MONITORING YEAR 4 ANNUAL REPORT

LONE HICKORY MITIGATION SITE

RE: Lone Hickory Mitigation Site – Monitoring Year 4 Report Draft
Yadkin River Basin – CU# 03040101 – Yadkin County
DMS Project ID No. 97135
Contract # 6897

Figure 3.4 Current Condition Plan View Map (Sheet 4)
 Lone Hickory Mitigation Site
 DMS Project No. 97135
 Monitoring Year 4 - 2022

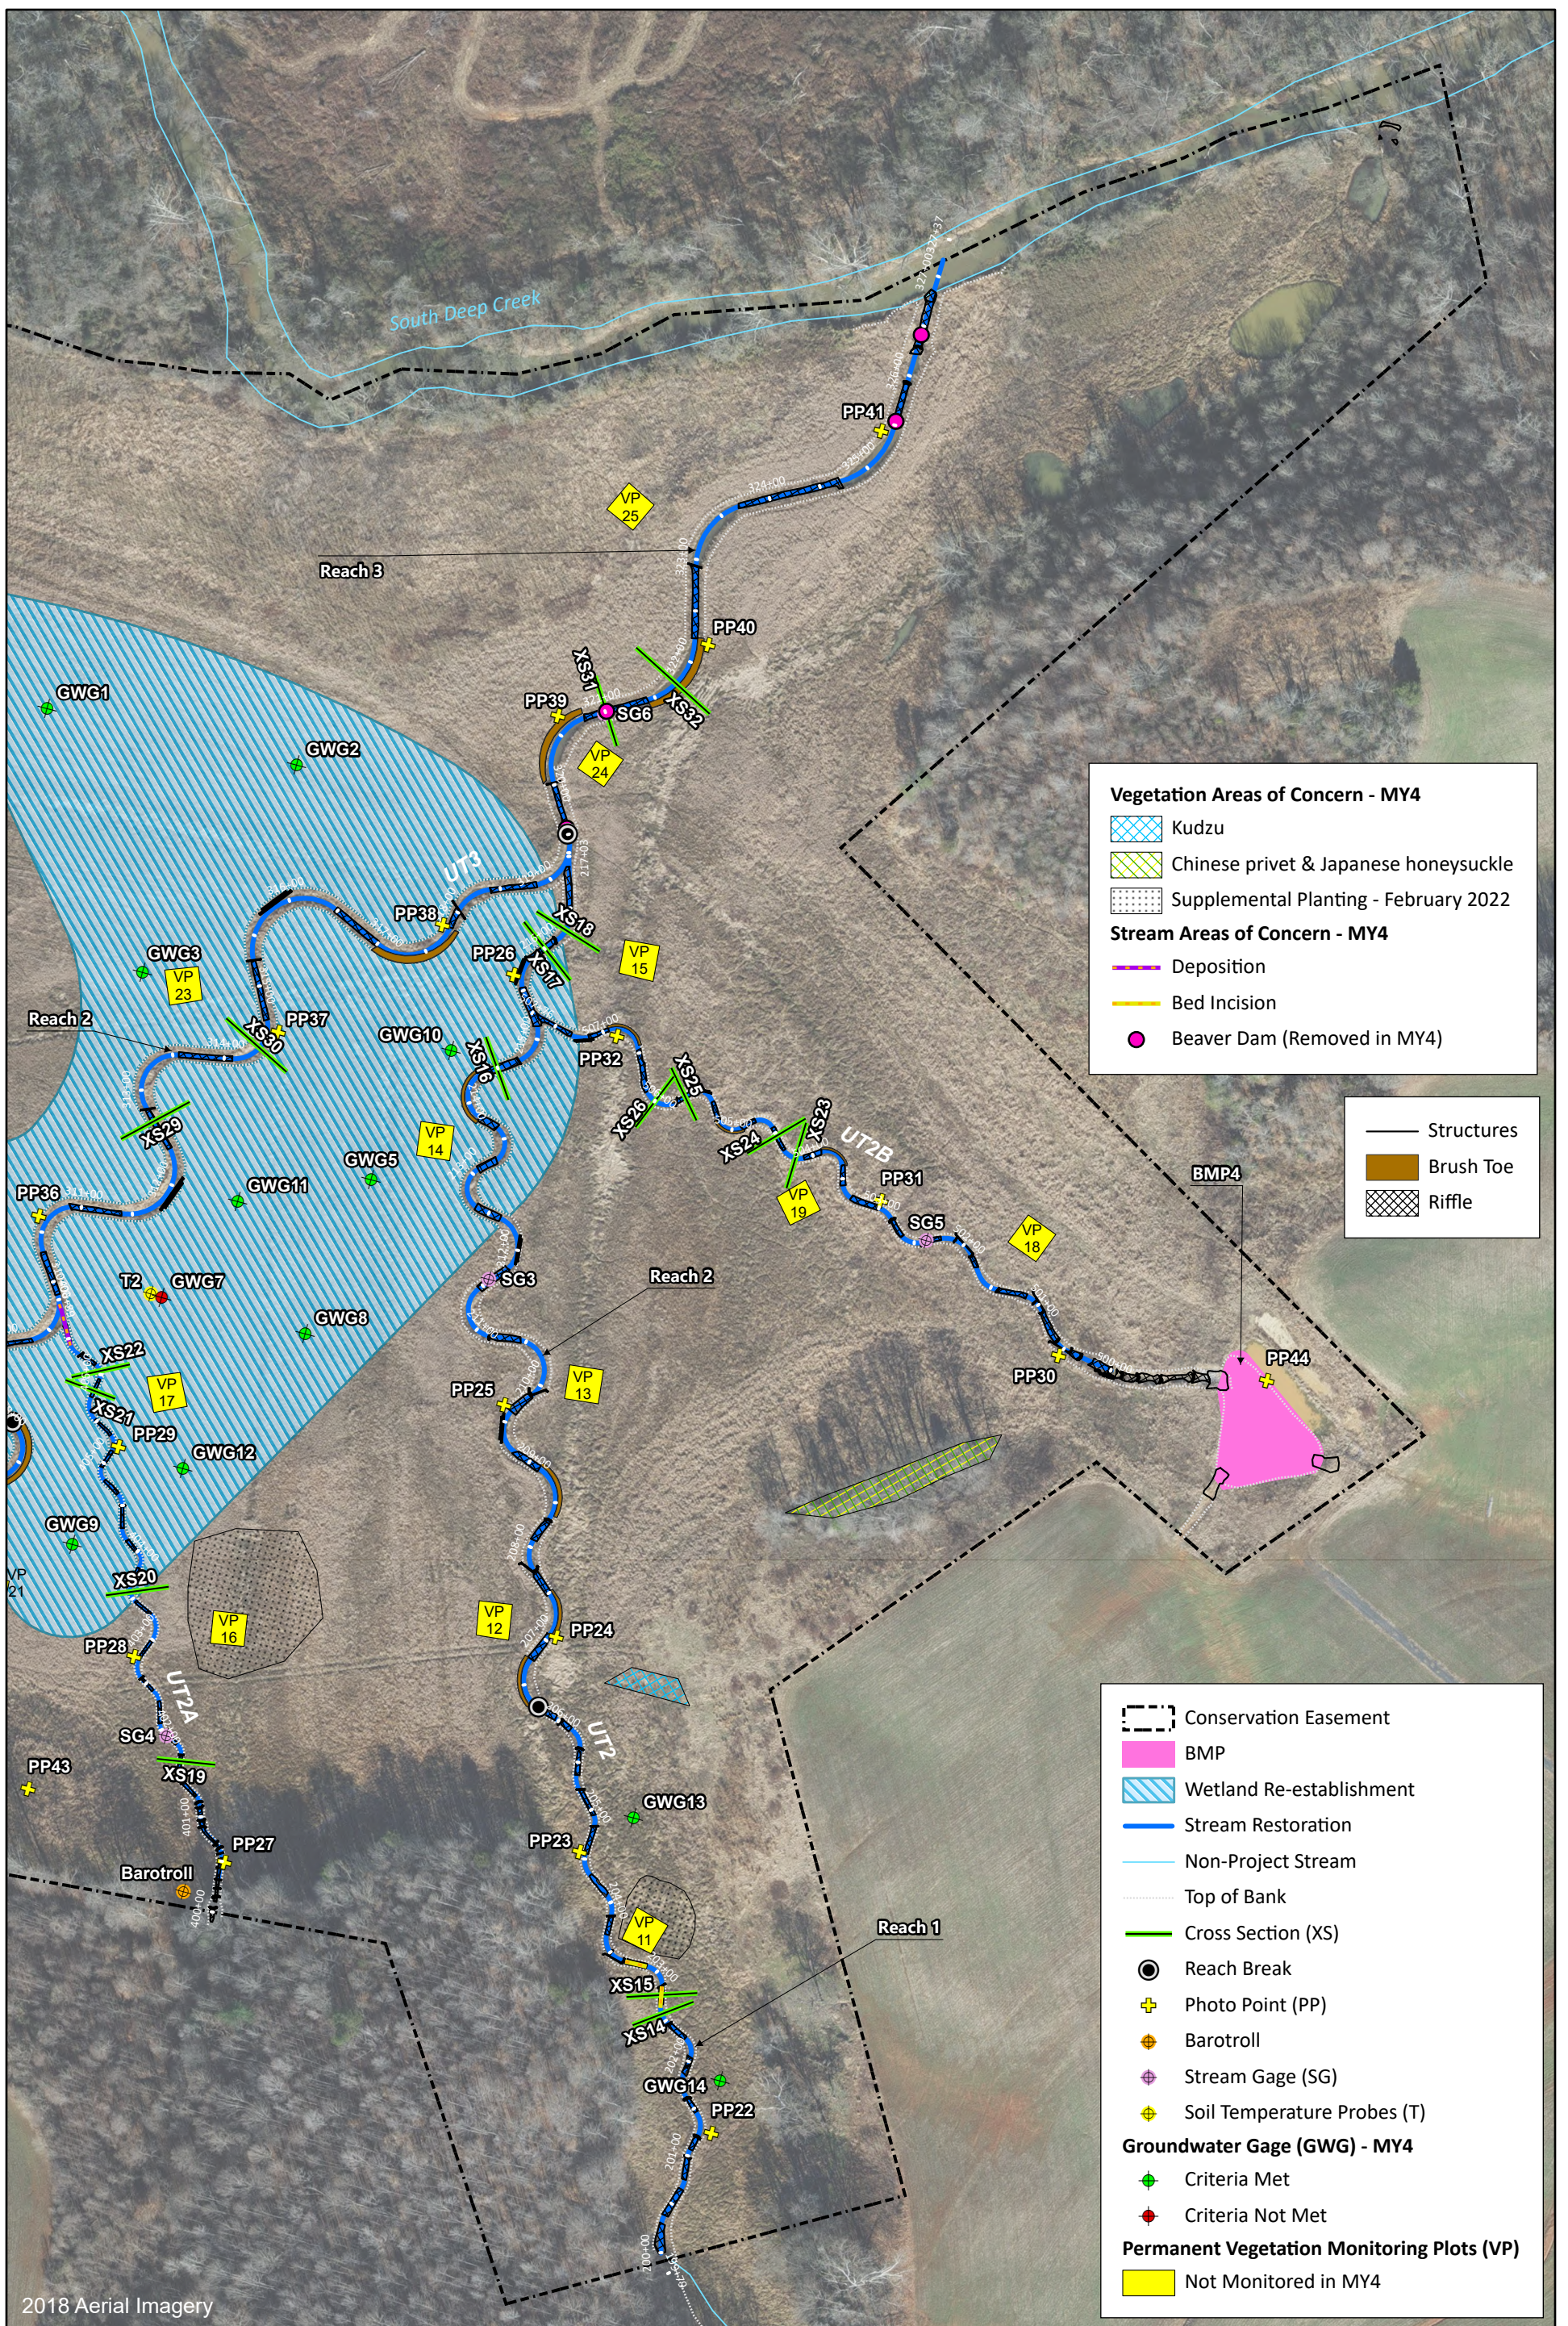
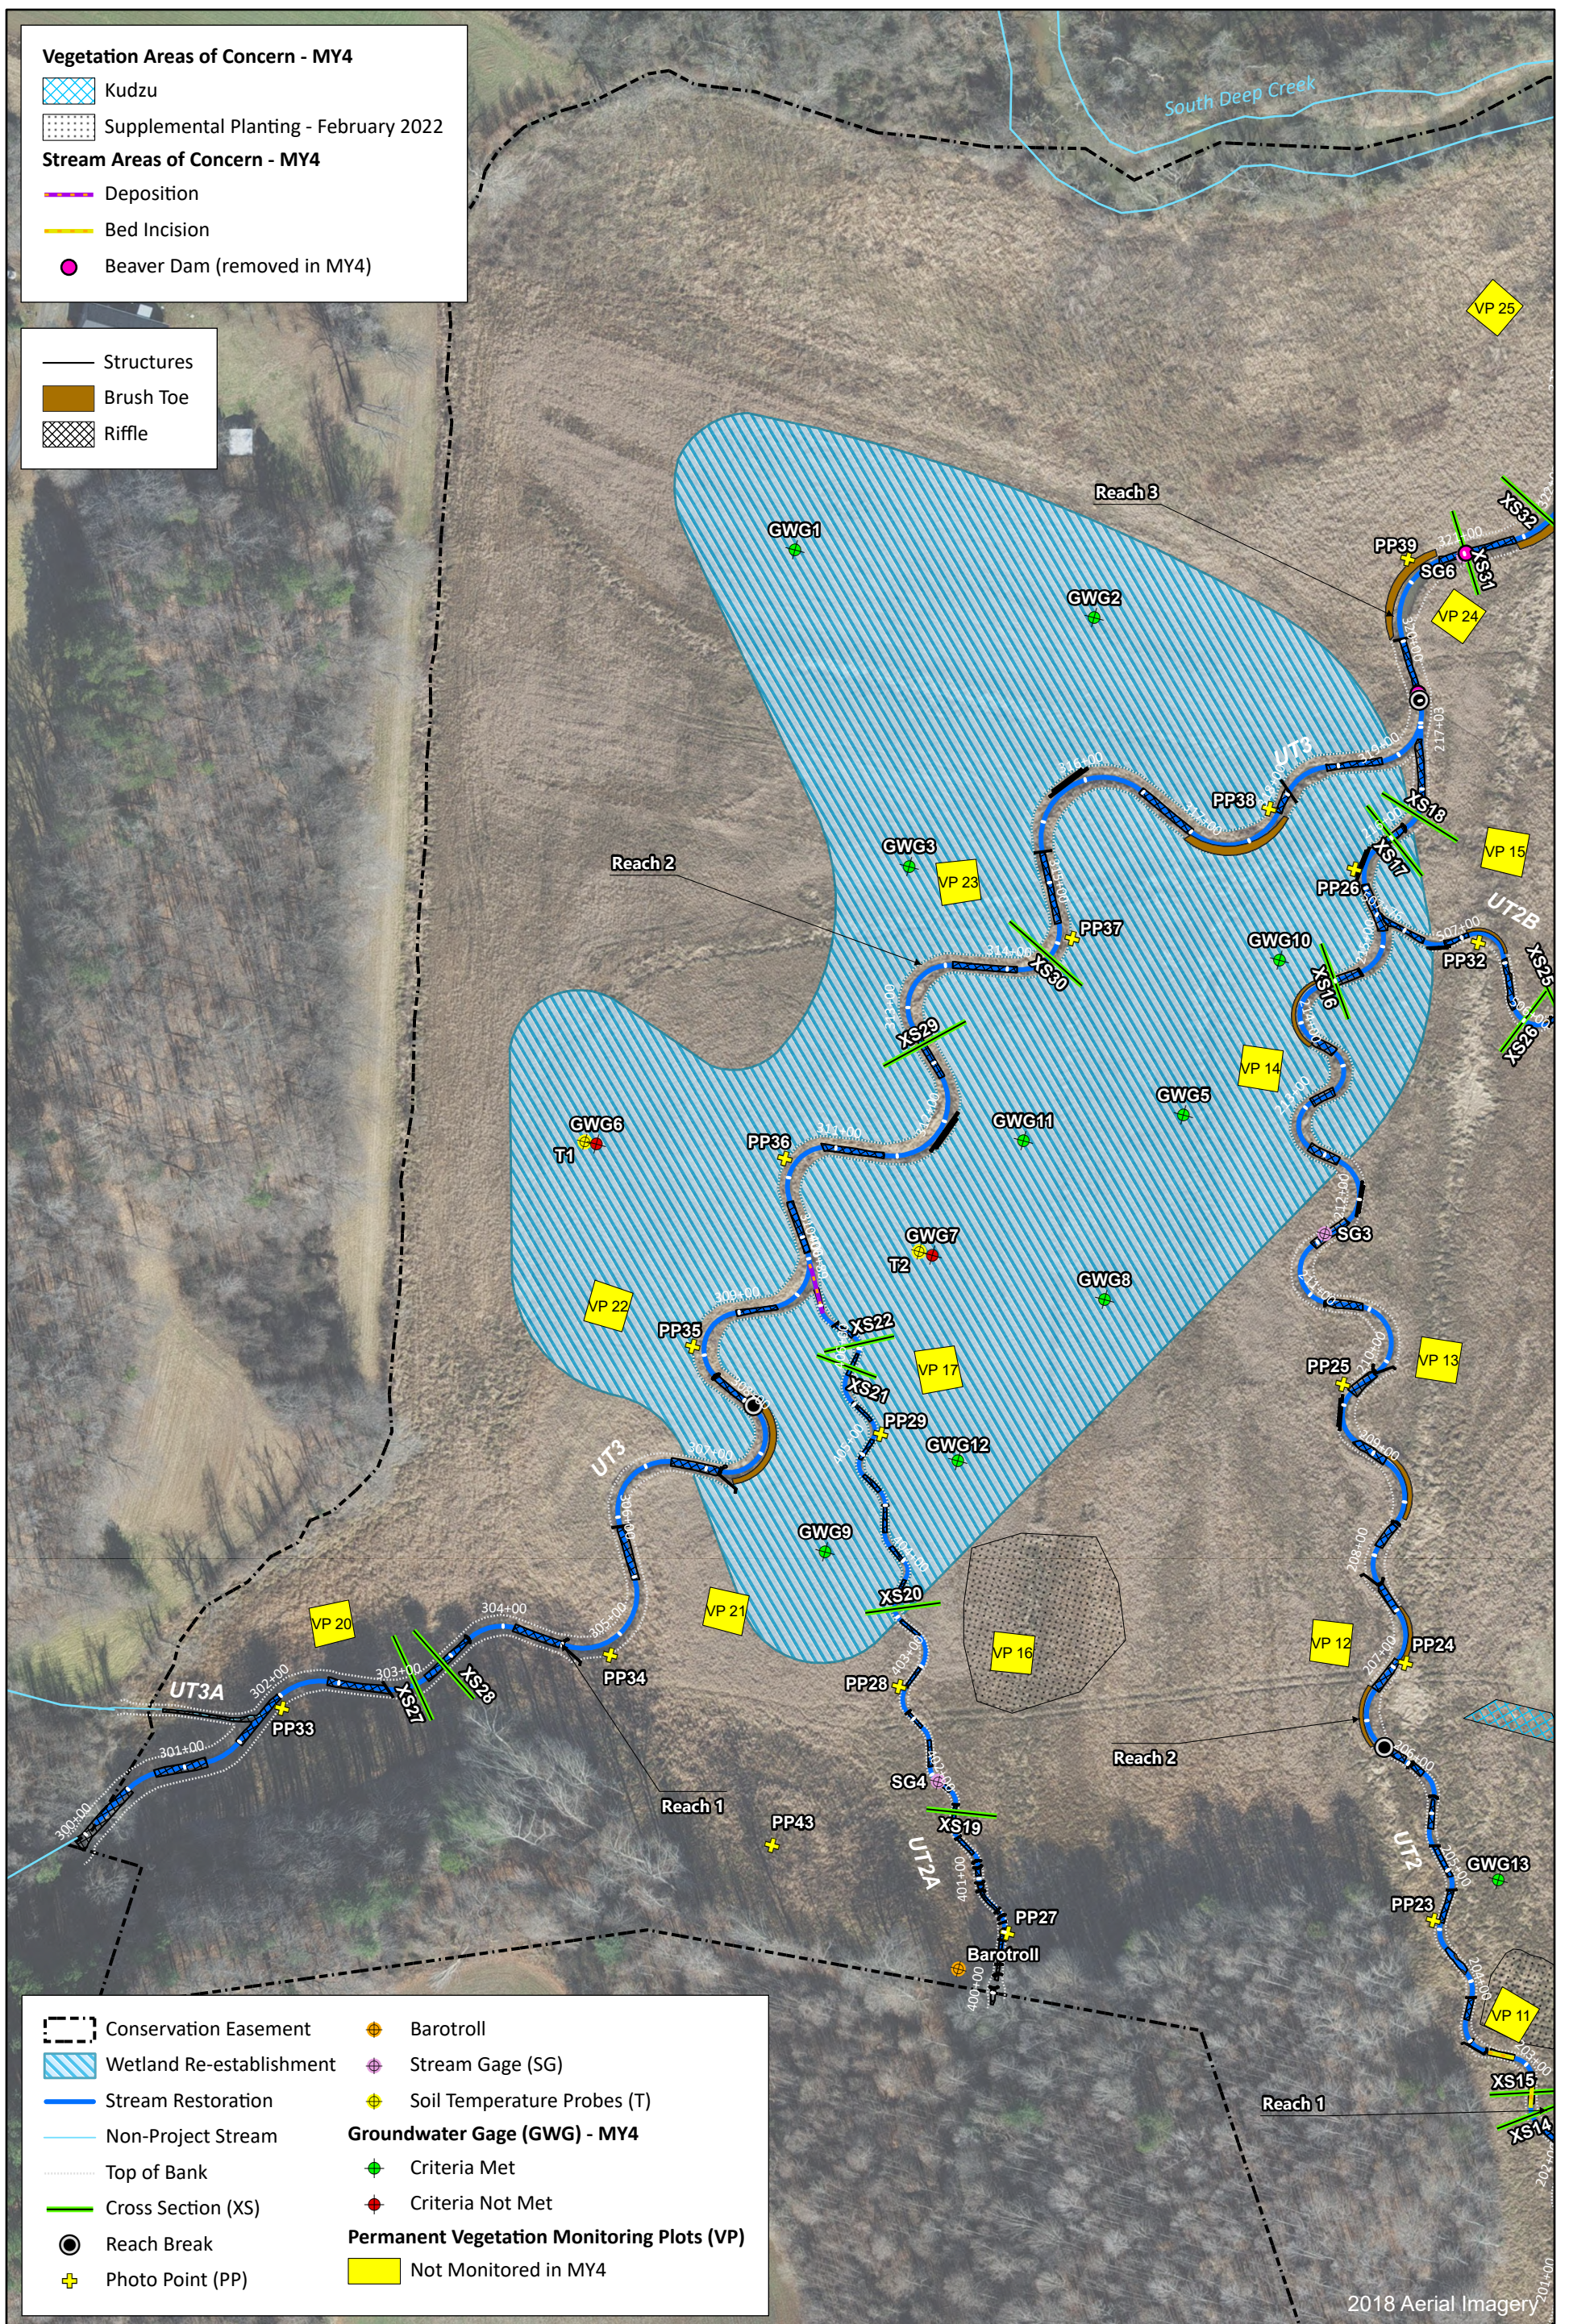
DMS' comment: CCPV Maps: Please show the two (2) established soil temperature probes on the applicable CCPV map sheets and update the digital support files accordingly.

Wildlands' response: The locations of the two soil temperatures probes have been added to the applicable CCPV figures. The digital GIS files have been updated to include the soil temperature probe feature class.
